Sport Package (Brembo) Brake Squeal

Market USA

YEAR(S)	MODEL(S)	ADDITIONAL INFORMATION
2010 – 2013	LS460

REVISION NOTICE

Figure 1.

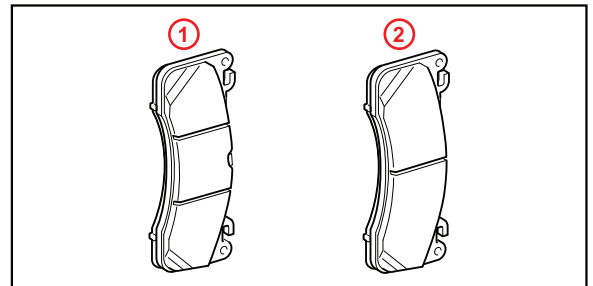
Ensure the single slit pads are installed on the inboard side of the calipers.
